NORTH STRATFIELD ELEMENTARY SCHOOL

190 PUTTING GREEN RD,
FAIRFIELD, CT 06825

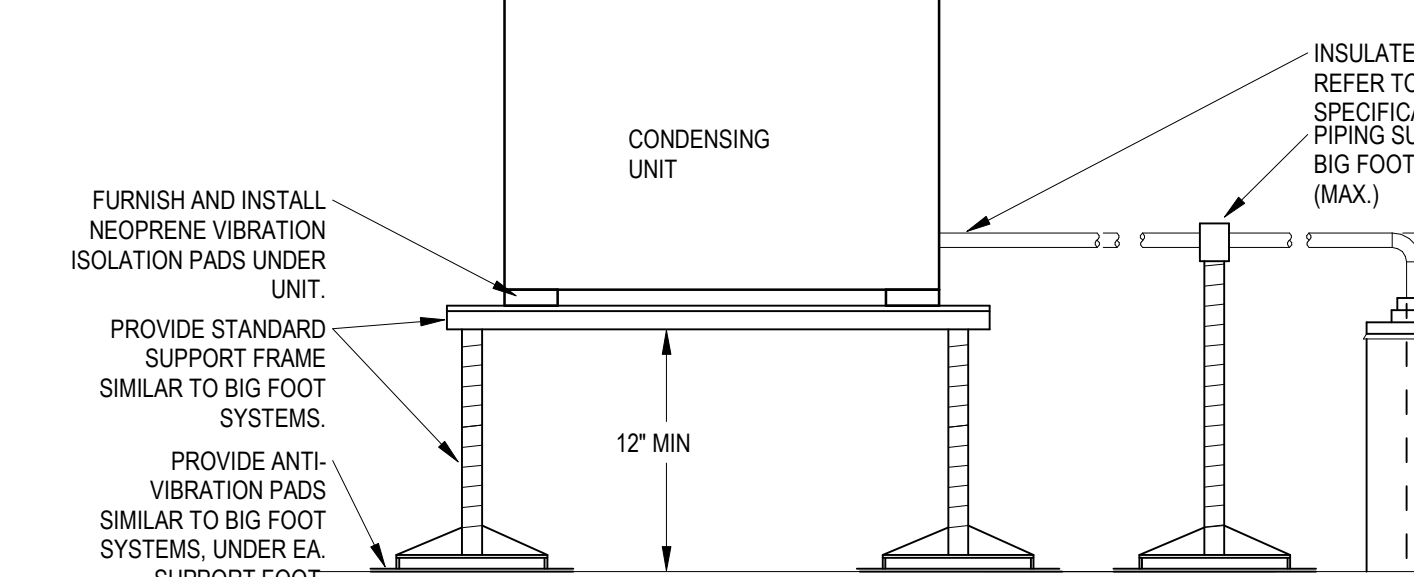
- NOTES:**
- CONTRACTOR SHALL PROVIDE MANUFACTURER DESIGNED EQUIPMENT SUPPORT SYSTEM FOR SUBMITTAL REVIEW.
 - FURNISH & INSTALL REFRIGERANT PIPING FROM CONDENSING UNIT TO INDOOR FAN COILS. NOTE THAT CONTRACTOR SHALL PRESSURE TEST THE REFRIGERANT PIPING WITH NITROGEN AT A PRESSURE & TIME RECOMMENDED BY MANUFACTURER & INDUSTRY PRACTICE TO ASSURE ALL PIPING IS FREE OF LEAKS.
